Product Change Notification: ALAN-10KOZF594

CCB 7276 Final Notice: Qualification palladium coated copper with gold flash (CuPdAu) as a new bond wire material for selected MCP3421, MCP4725, MCP4726, MCP4706, MCP4716, MCP9510, MCP47DA1, MCP4023, MCP4022, MCP4013, MCP4012, and MCP3425 device families available in 6L SOT-23 package.

PCN Status: Final Notification

PCN Type: Manufacturing Change

Pre and Post Change Summary

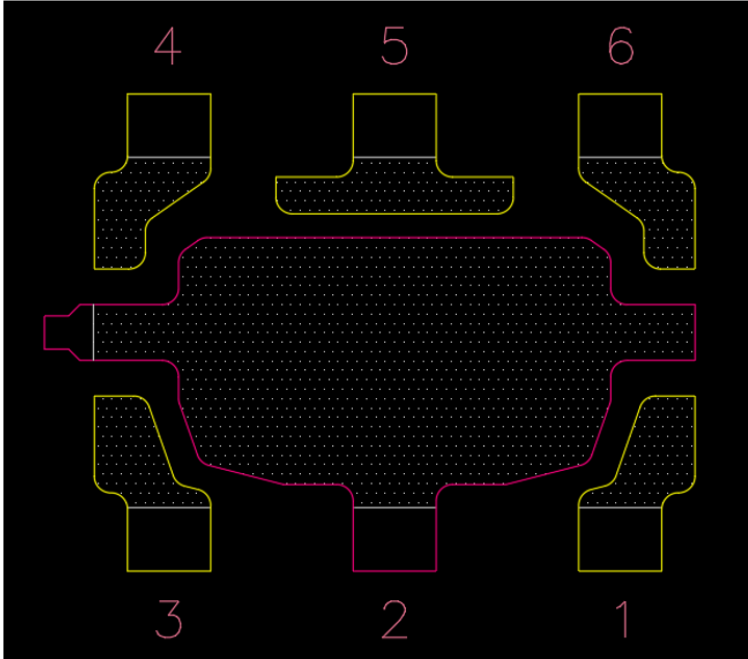
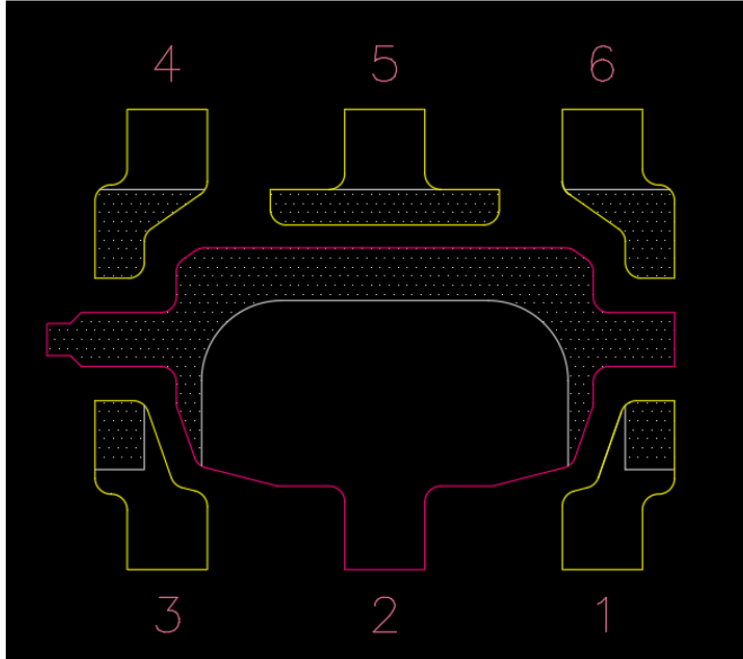
Pre Change		Post Change

Lead-Frame Material	CDA194	Lead-Frame Material	A194
DAP Surface Prep	Ag Spot Plated	DAP Surface Prep	Ag single ring Plated

Note: C194, A194, or CDA194 Lead-frame material are the same, it is just a MCHP internal labelling difference.
